h4 Doc  
RESPONSE TO FREEDOM OF INFORMATION ACT (FOIA) / PRIVACY ACT (PA) REQUEST

2000-0096

FACILITIES: Shearon Harris Nuclear Power Plant, Unit 1

SHEARON HARRIS NUCLEAR POWER PLANT  
DOCKET NO. 50-400/LICENSE NO. NPF-63  
RESPONSE TO NRC REQUEST FOR ADDITIONAL  
INFORMATION REGARDING THE ALTERNATIVE  
PLAN FOR SPENT FUEL POOLS C & D COOLING  
AND CLEANUP SYSTEM PIPING

Figure RAI 2.1

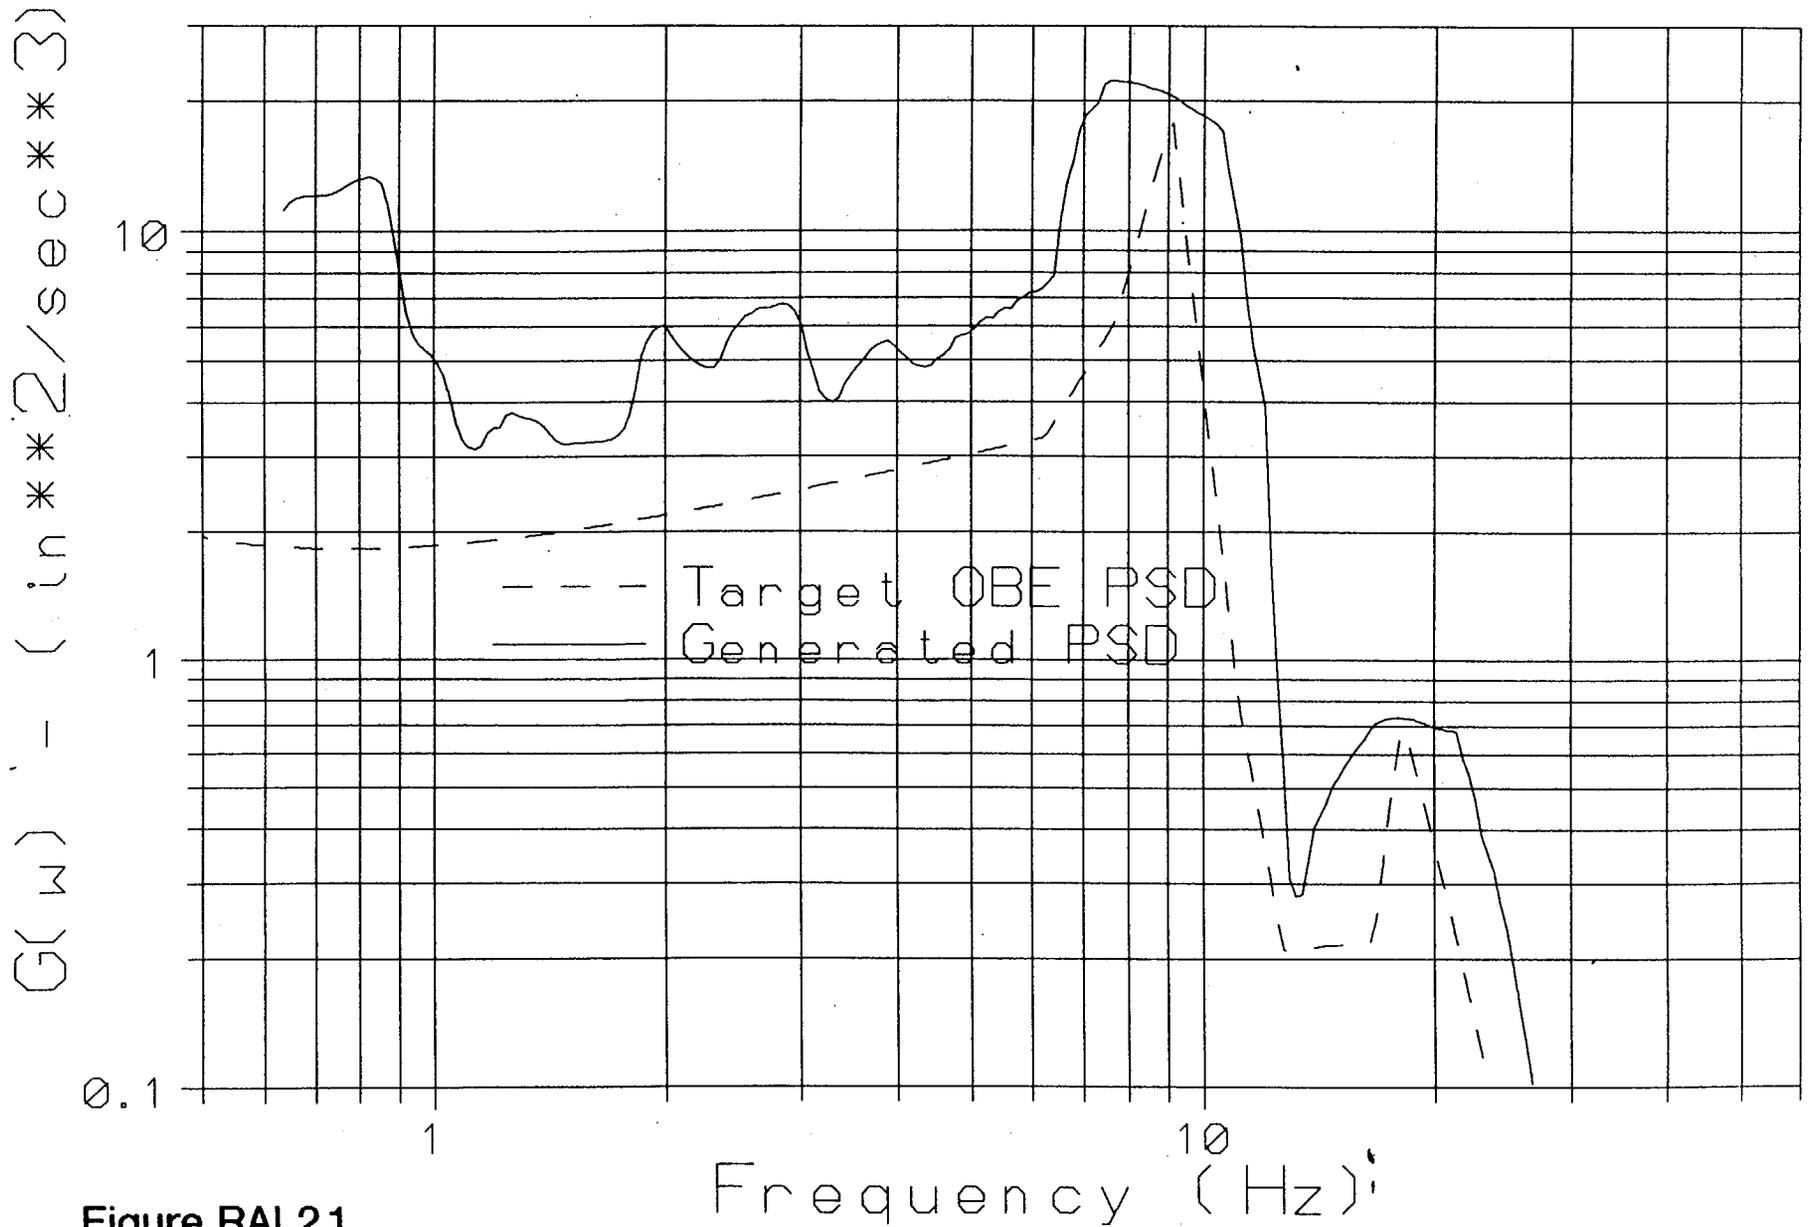
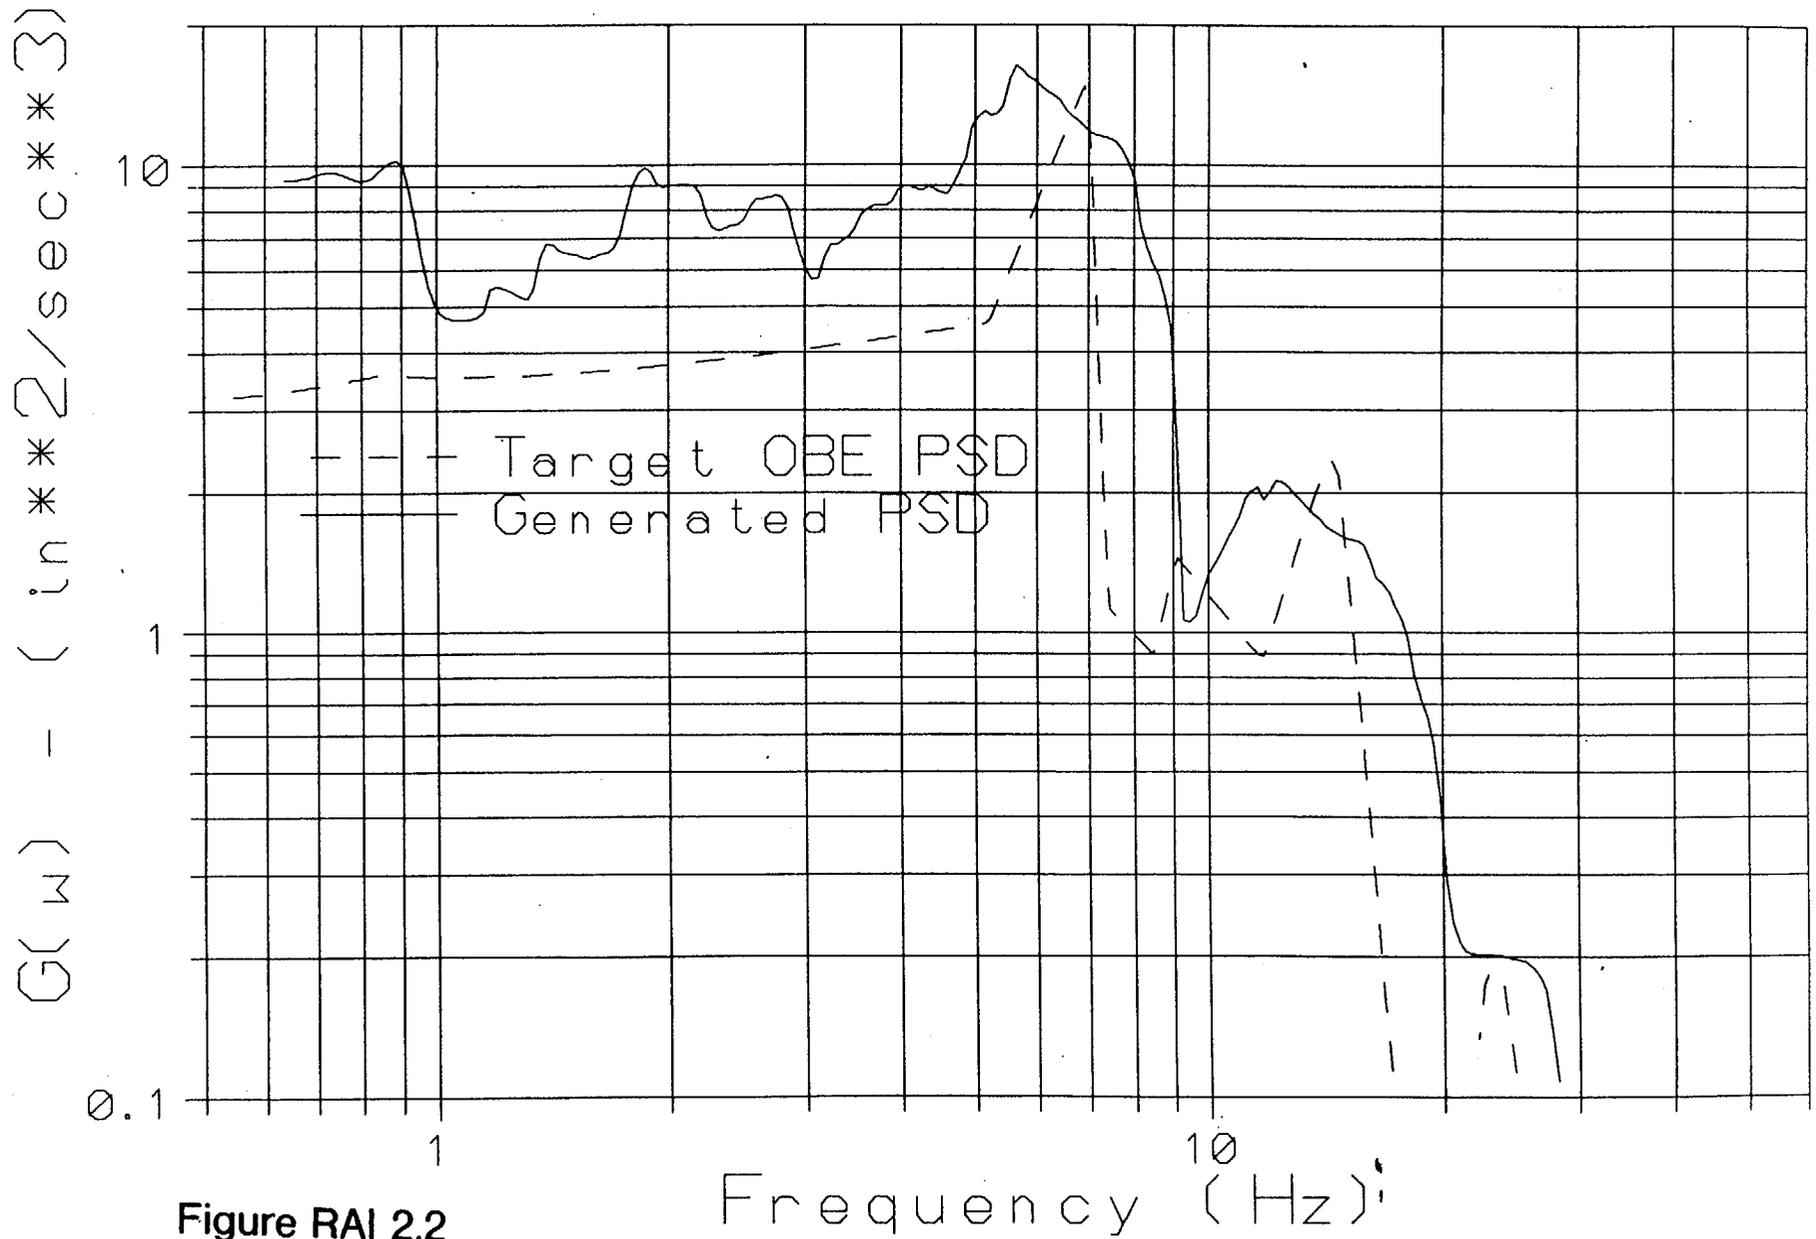
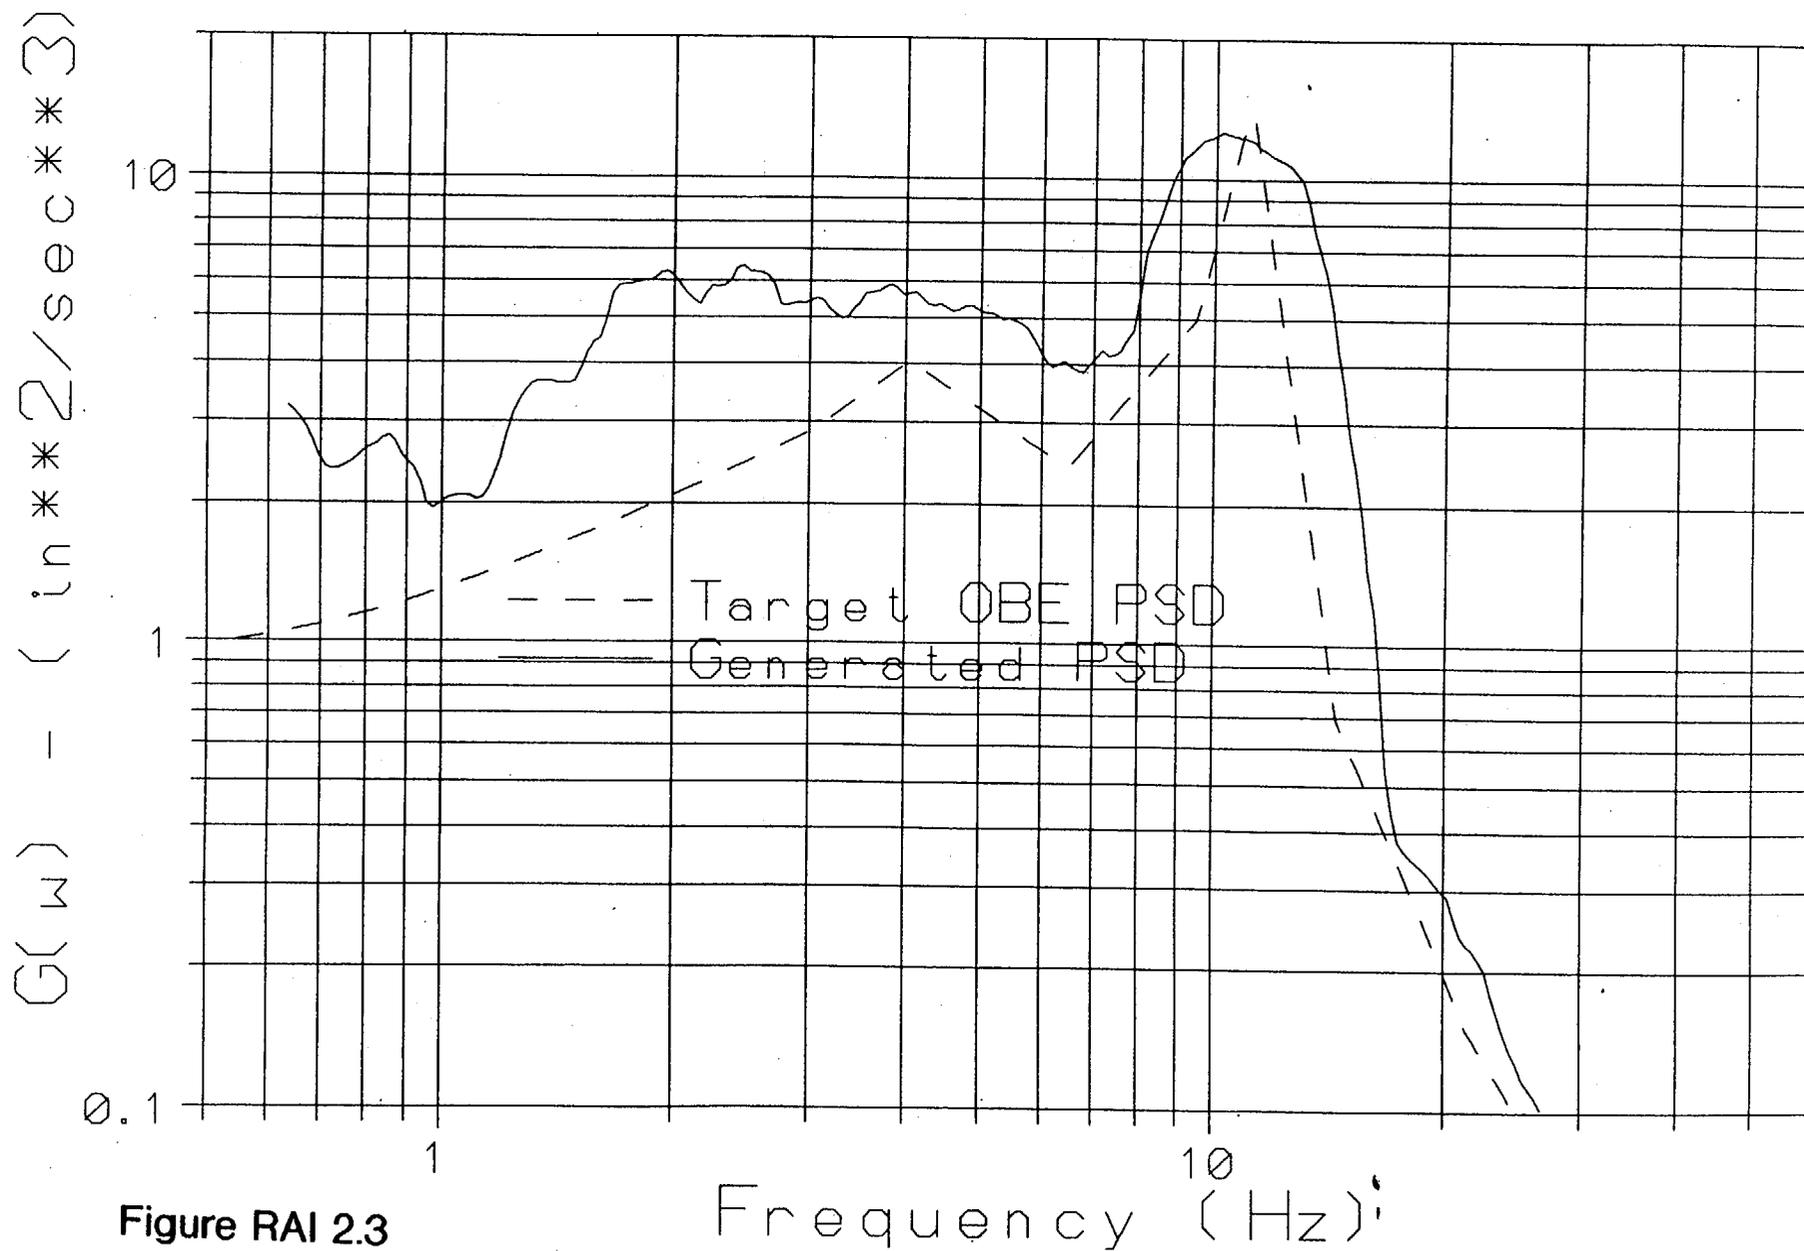
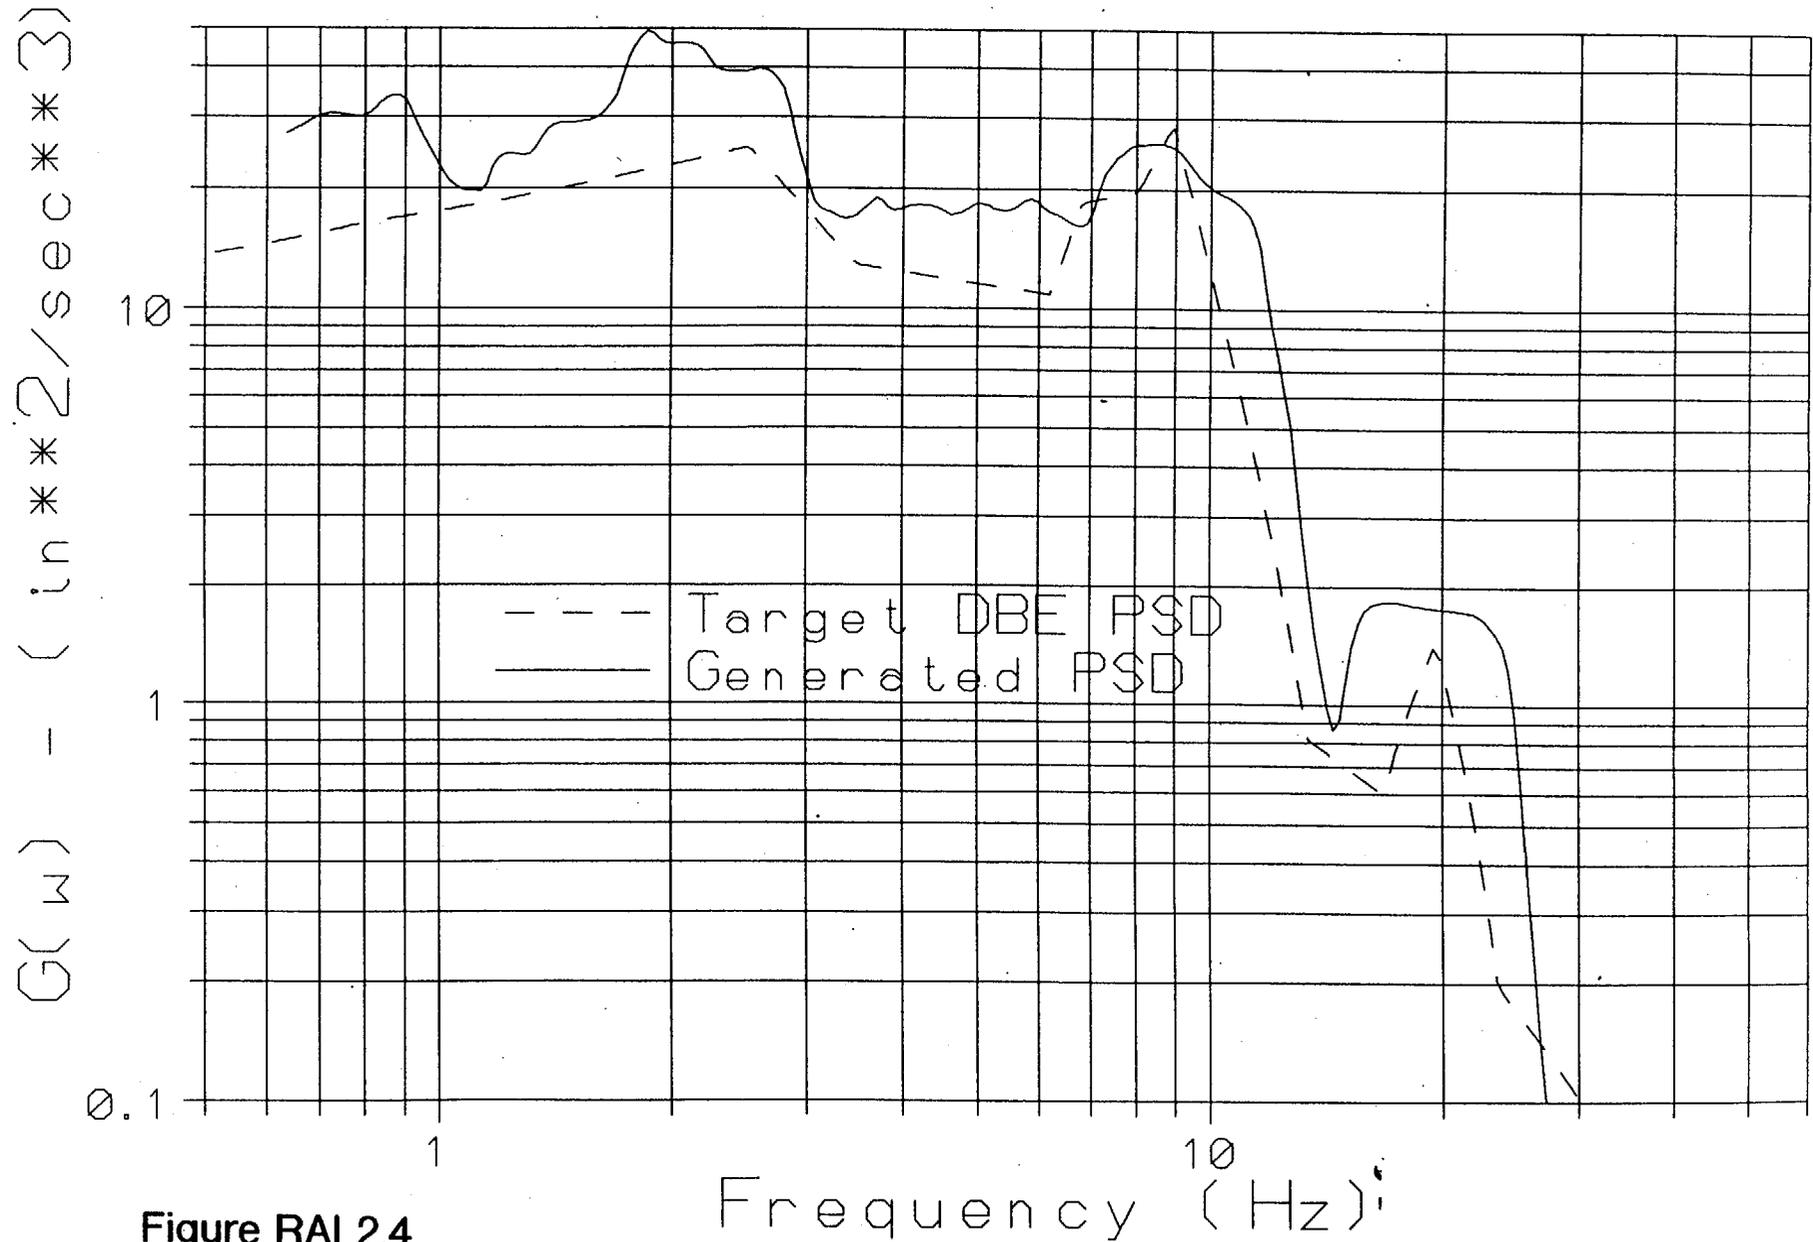
Holtec Report HI-971702 provides the details of the development of the time histories used for the Shearon Harris spent fuel pool from the design basis Response Spectra. Figures RAI 2.1 through 2.6 (Enclosure 2), reproduced from the aforementioned report, demonstrate the required enveloping of the target PSD over the frequency range important to spent fuel racks (3-7 Hz) by the PSD regenerated from the developed time histories.
